# Working Instruction

<b>Theme</b>	To rework DR100 series using new RS-06 SVC Loader
<b>Reason</b>	Replacing RS-01 with RS-06 owing to no more production of 812 pickup
<b>Method</b>	<p>• <b>AA336470824 : SVC Loader Assy (Included Cable)</b></p> <div style="border: 1px solid black; padding: 5px; margin: 5px 0;"> <p>• <b>RS-06 SVC Loader</b>      • <b>EAD35827401 : Harness Cable 4pin 160mm</b></p> <p>• <b>EAD56414501 : FFC Cable 40pin 180mm</b></p> </div> <p><b>※ Preparation</b></p> <p><b>FFC cable should be folded like below before assembling to loader</b></p> <p>①   A side of EAD56414501 should be folded. The length is 60 mm.</p> <p>②   You should assemble EAD56414501 (FFC) and EAD35827401 (Harness) to RS-06 SVC Loader (a) part should be assembled to Loader</p> <p>③   <b>Completion !!!</b></p>

<b>Theme</b>	To rework RC100 series using new RS-06 Loader
<b>Reason</b>	Replacing RS-01 with RS-06 owing to no more production of 812 pickup
<b>Method</b>	<ul style="list-style-type: none"> <li>• <b>AAX36470824 : SVC Loader Assy (Included Cable)</b></li> </ul> <div style="display: flex; justify-content: space-around; align-items: flex-start;"> <div style="text-align: center;">  <p>• <b>RS-

**FFC cable should be folded like below before assembling to loader**

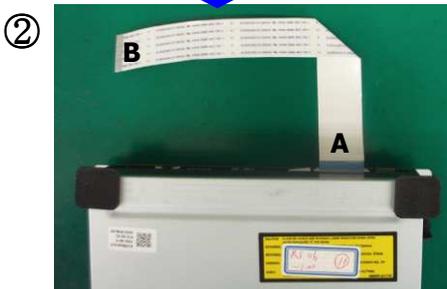
The FFC cable, A is 10 mm,  
B is 70 mm .  
(Total length of FFC is 180 mm)

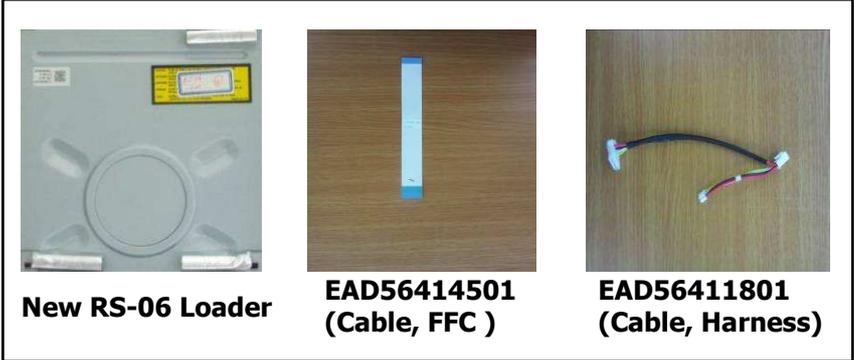
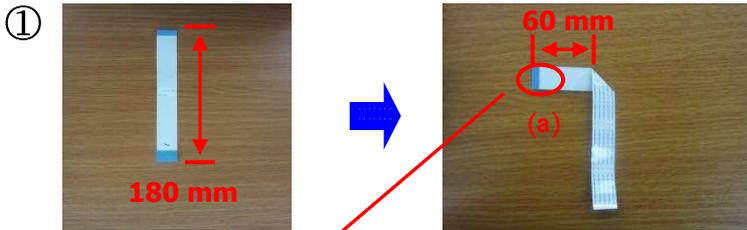
You should assemble EAD56414501 (FFC) and EAD56411801 (Harness) to RS-06 Loader

(a) part should be assembled to Loader

FFC cable should be folded like below before assembling to loader

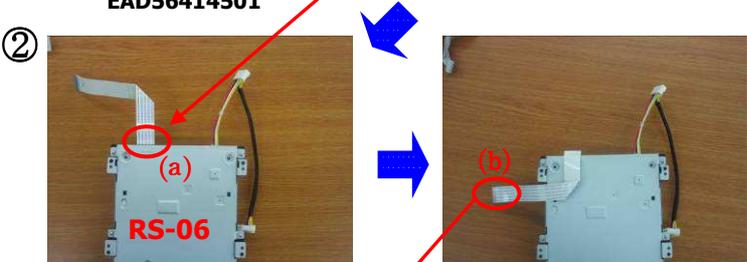
A side of EAD56414501 should be folded. The length is 60 mm.
